**ARCHITECTURAL ADDENDUM  
ADD #3**

Re: **Hilliard Township Office Addition  
951678 Hwy 569  
Hilliardton, ON P0J 1P0**

Project No. **22013**

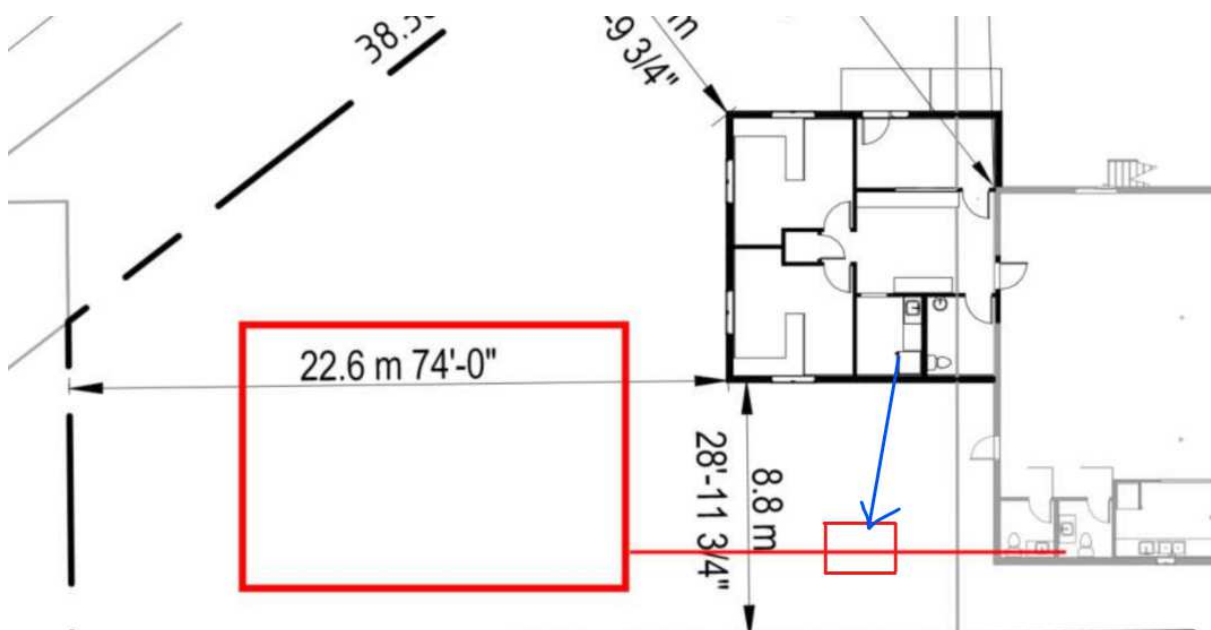
- Q1: How will the new sanitary pipe be connected to the existing system?  
A1: The awarded contractor will be responsible for determining the best possible solution in order to connect the new sanitary system to the existing system. For bidding purposes, the contractor shall assume that a simple connection to the main sanitary pipe or to the septic tank is feasible at the location shown in blue below::
